STATE OF MAINE
DEPARTMENT OF TRANSPORTATION
16 STATE HOUSE STATION
AUGUSTA, MAINE 04333-0016

January 12, 2026
Subject: Chase Mills Bridge #5465
Bridge Replacement Project
State WIN: 025529.00
Location: **East Machias**
Amendment No. 1

Please make the following changes to the Bid Documents:

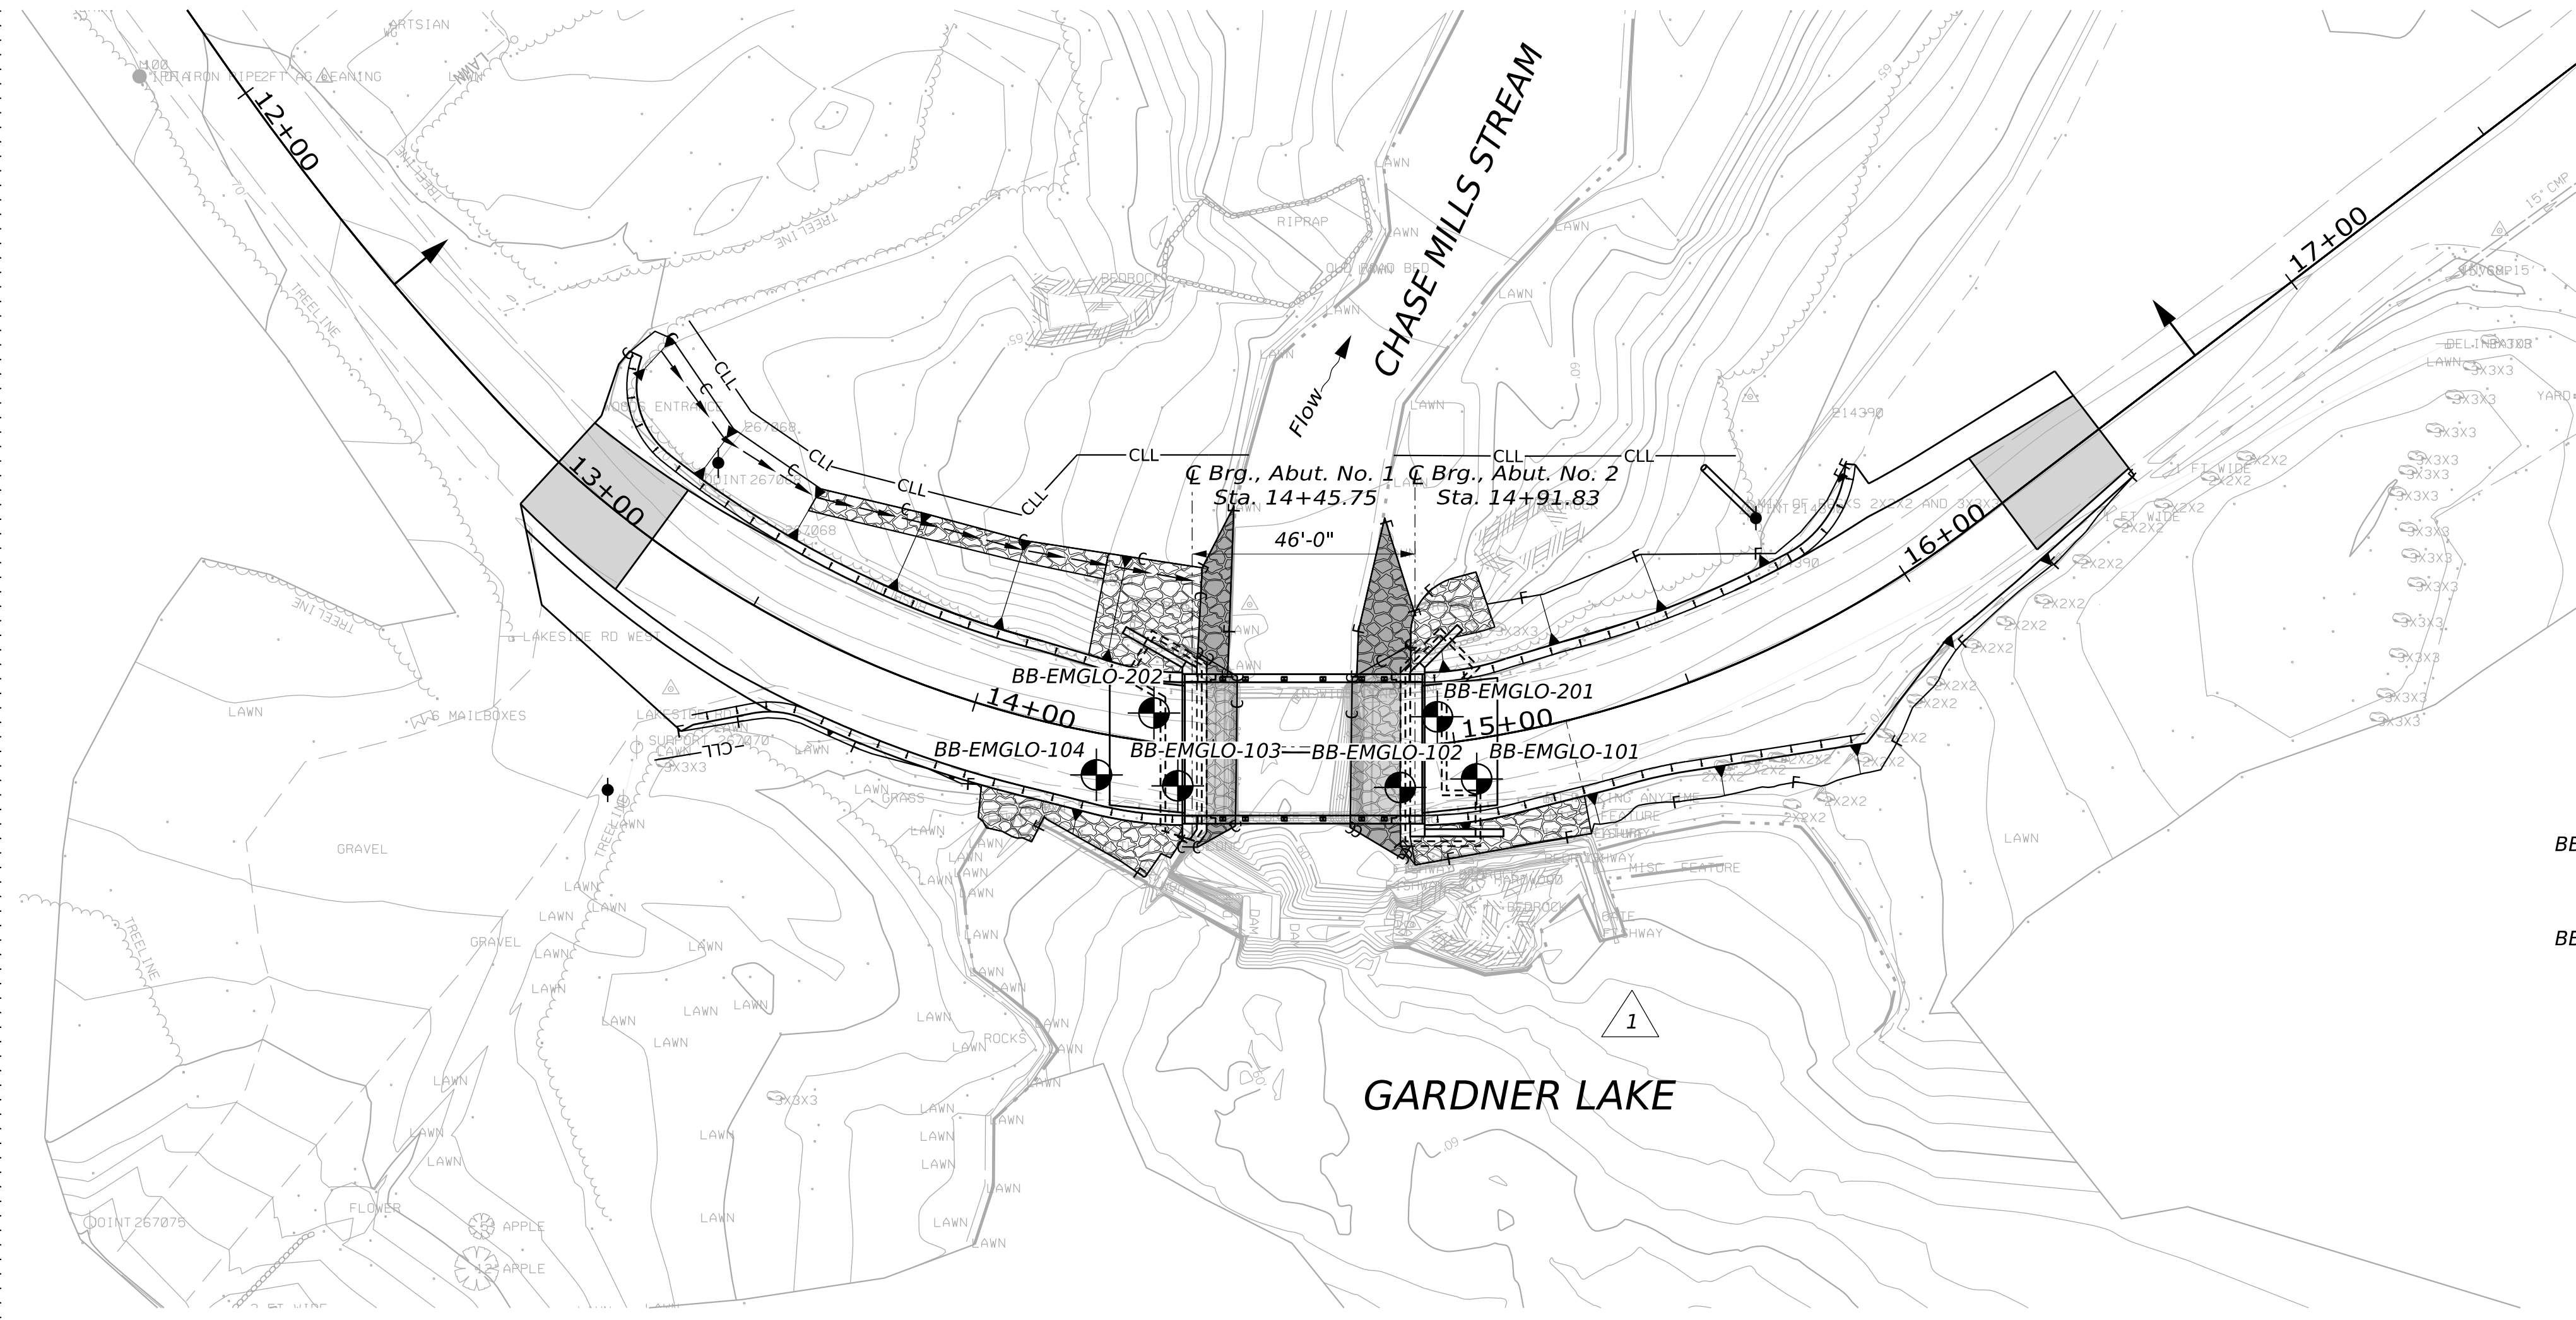
REMOVE SHEET NUMBER 2 OF 32, ESTIMATED QUANTITIES AND GENERAL CONSTRUCTION NOTES, dated Dec 2025, and **REPLACE** with the attached, revised SHEET NUMBER 2 OF 32, ESTIMATED QUANTITIES, dated 1/9/2026.

- The existing fishway and dam are to remain. The extents are unknown. Payment for support of the dam and fishway during construction will be made under Pay Item 524.301 Temporary Structural Support - Dam and Fishway.
